Appendix I of RNTPC  
Paper No. A/YL-NTM/466B

**APPLICATION FOR PERMISSION  
UNDER SECTION 16 OF  
THE TOWN PLANNING ORDINANCE  
(CAP.131)**

**Proposed Temporary Public Vehicle Park for Private Cars and Light Goods Vehicles for a Period of 3 Years**  
**at**  
**Lots 830, 831 in D.D. 102, Lots 397 (Part), 401 (Part) in D.D.105 & Adjoining Government Land, Shek Wu Wai, Yuen Long, N.T.**

**Proposed Temporary Public Vehicle Park for Private Cars & Light Goods Vehicles for a Period of 3 Years at Lots 830, 831 in D.D. 102, Lots 397 (Part), 401 (Part) in D.D.105 & Adjoining Government Land, Shek Wu Wai, Yuen Long, N.T.**

Proposed Drainage Plan

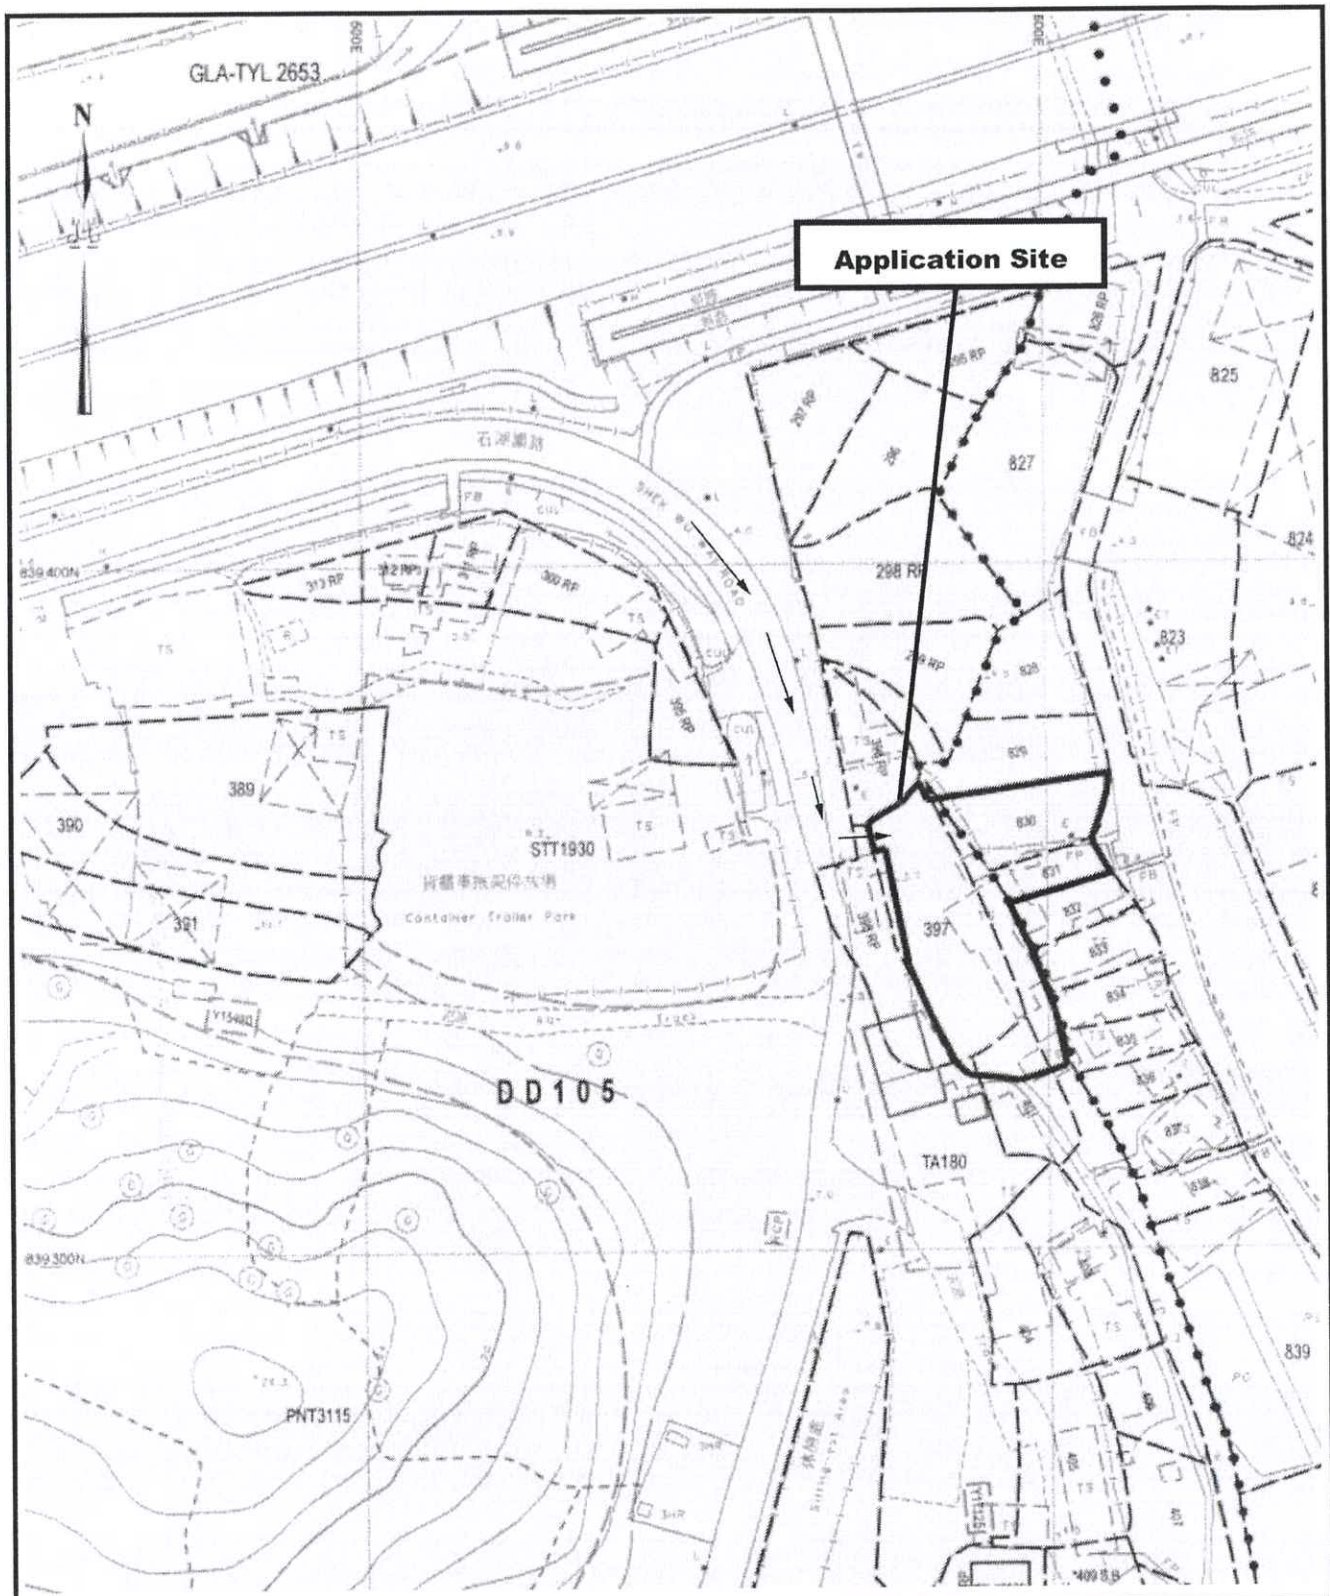
- 1.1.8 According to recent site inspection, there is a open drain to the east of the application site (**Figure 4**).

- 1.2.1 Subject to the calculations below, it is determined that 450mm surface U-channel which is made of concrete is required along the site periphery to intercept storm water passing through and generated at the application site. (**Figure 4**)

- 1.2.2 The collected surface runoff will be conveyed to open drain to the immediate east of the application site. (**Figure 4**)
- 1.2.3 The calculations in **Annex 1.3** shows that the proposed 450mm surface U-channel has adequate capacity to cater for the surface runoff generated at the subject site.

Figure 4

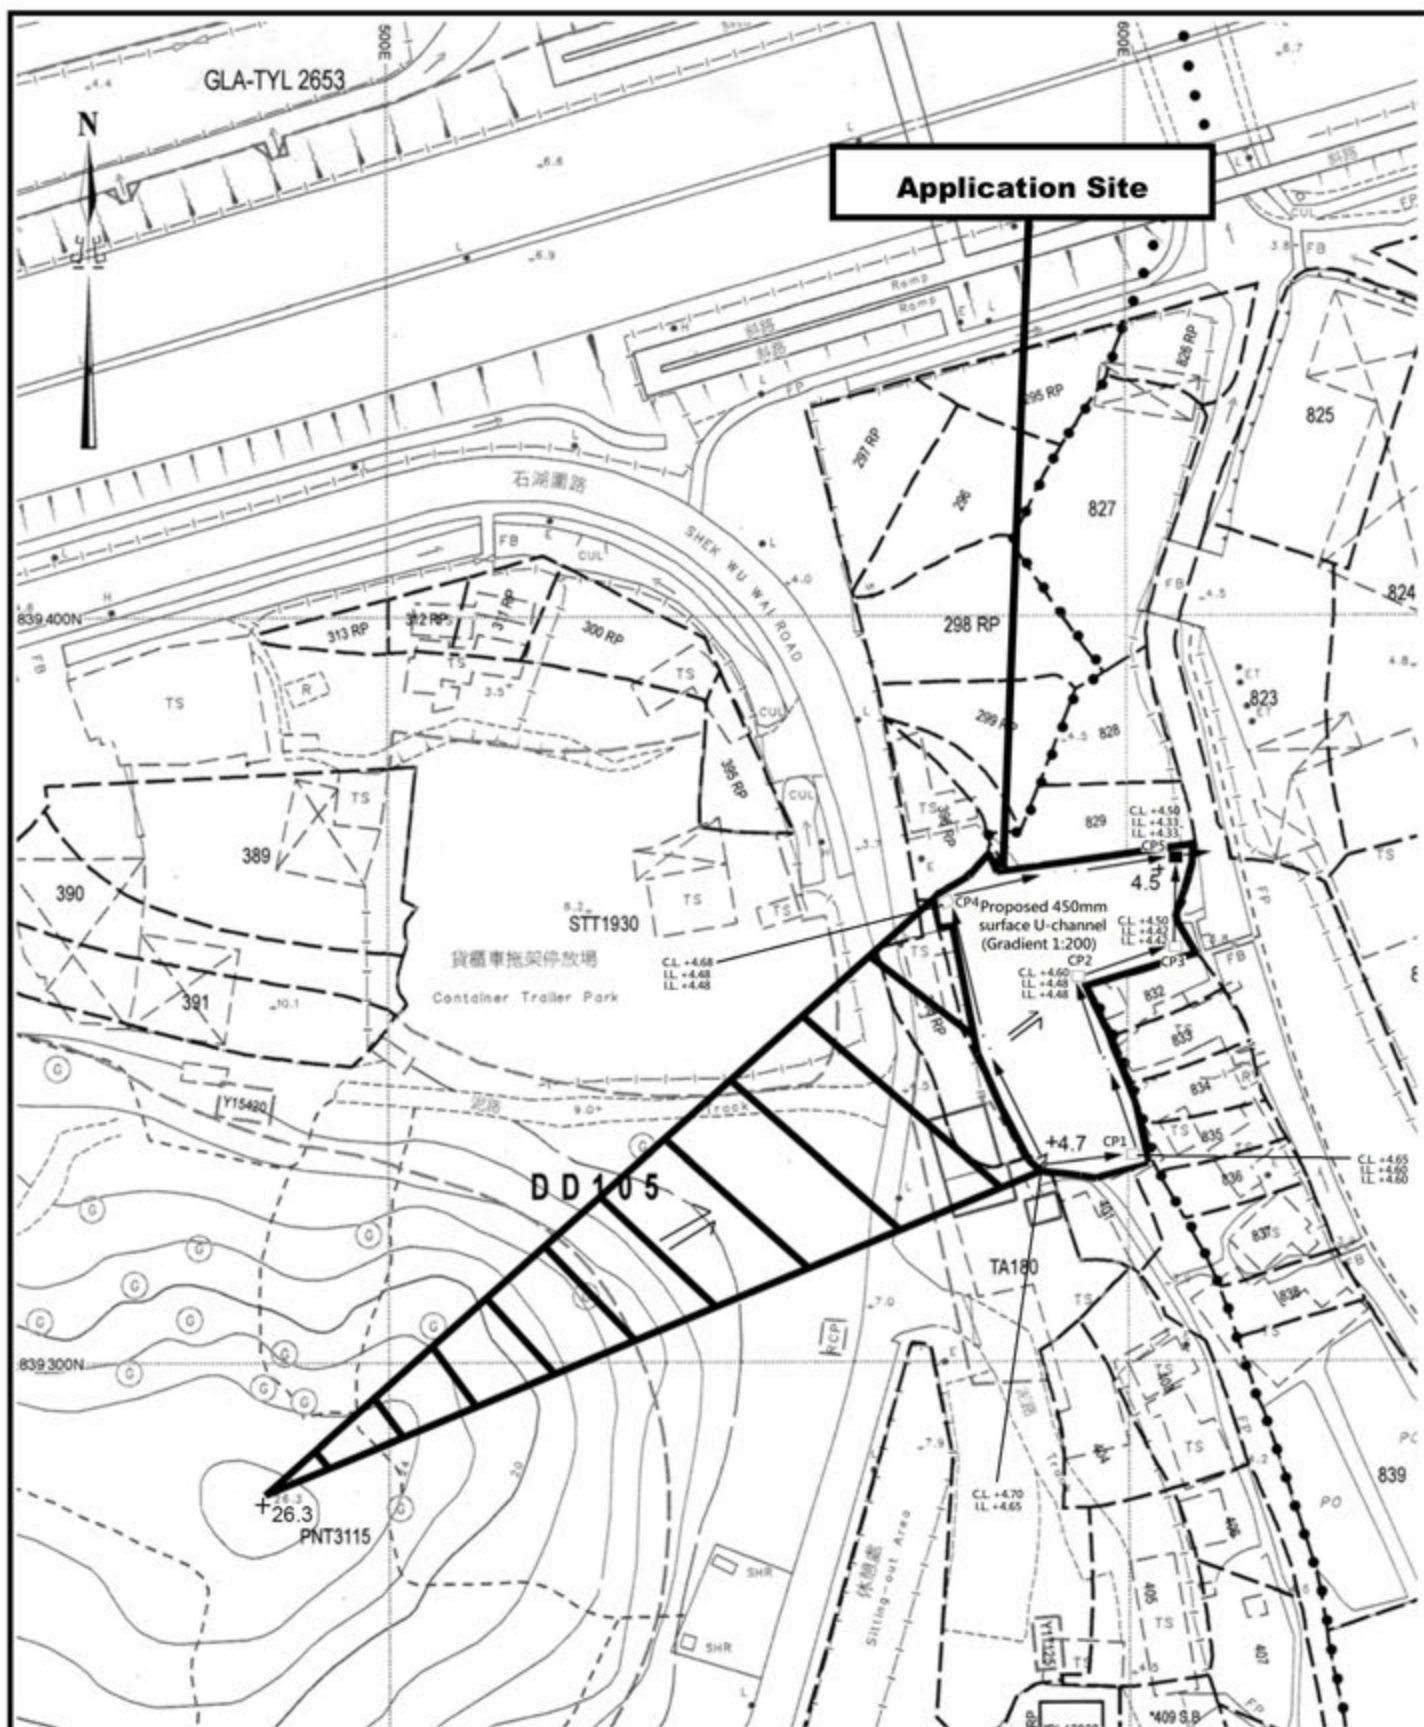
CE/MN, DSD's comments	Applicant's response
1. Inconsistency in the adopted rainfall intensity is found between 265 mm/hr on P.3 and 275 mm/hr on P.4. Nevertheless, reference shall be made to latest version of the Stormwater Drainage Manual with Corrigendum No. 1/2022. In particular for design rainfall for drainage assessment submission, please refer to Section 4.3.3.	Noted. The rainfall intensity is adjusted to 307.4mm/hr.

2. As mentioned in the assessment, the application site had been hard paved, please advise any additional run-off will be generated from this planning application.	Noted. The rainfall intensity is 265mm/hr according to the attachment. After increased by 16%, it becomes 307.4mm/hr. Please see the adjusted drainage calculation.

- The area of the entire catchment is approximately 3,300m<sup>2</sup>; (**Figure 4**)
- The application site is totally paved and therefore the value of run-off co-efficient (k) is taken as 1.

$$\therefore Q = 281.78 \text{ l/s} = 16,907 \text{ l/min}$$

In accordance with the Chart or the Rapid Design of Channels in “Geotechnical Manual for Slopes”, 450mm surface U-channel at gradient 1:200 is considered adequate to dissipate all the stormwater accrued by the application site. The intercepted stormwater will then be discharged to the public drain at the northern site periphery.
